**Dealer  
Service  
Bulletin**

**NO.:** 7SB007-24-01A

**AFFECTED:** 2024 Revel and Solis T36B

**SUBJECT:** EcoFlow Power Hub Pro

# SETTINGS -> SOFTWARE UPDATE

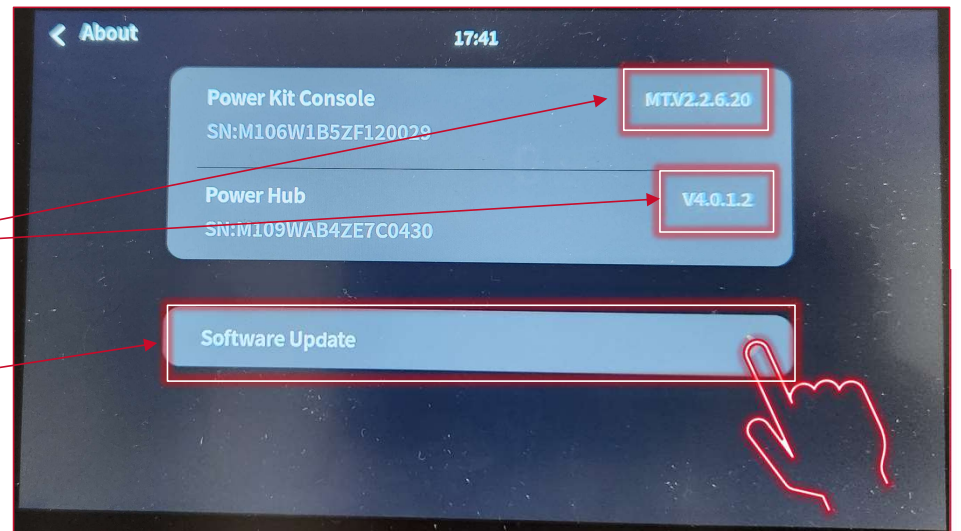
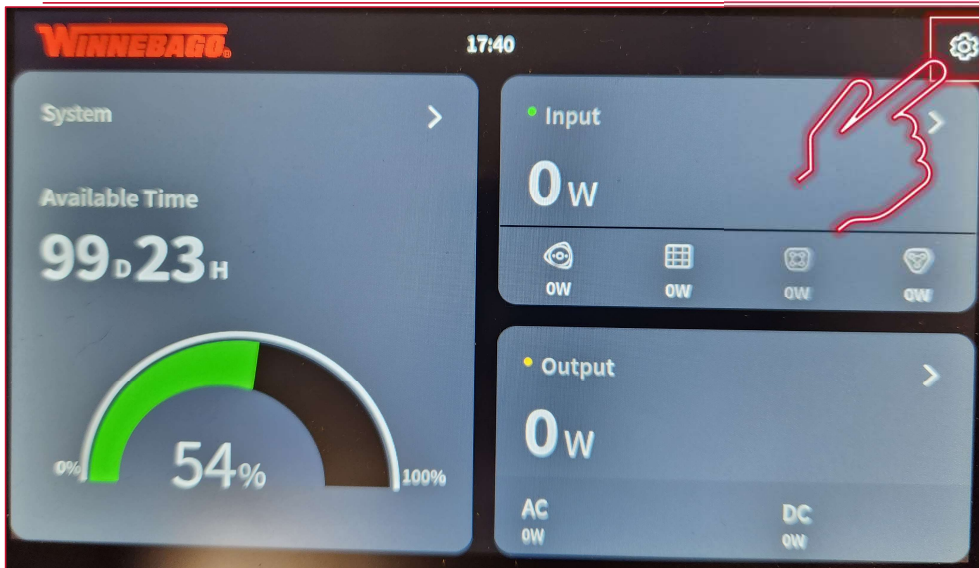
Check Firmware Versions here

Update Firmware here

## IF UPDATE AVAILABLE

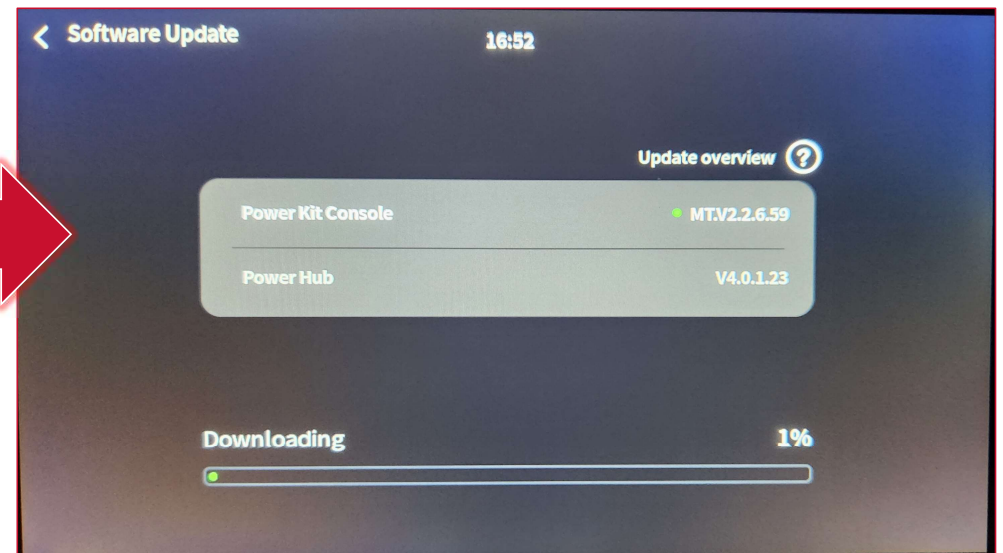
Press 'Upgrade' to download update

Wait for download to complete.  
Do not disconnect from WiFi or  
remove device providing WiFi
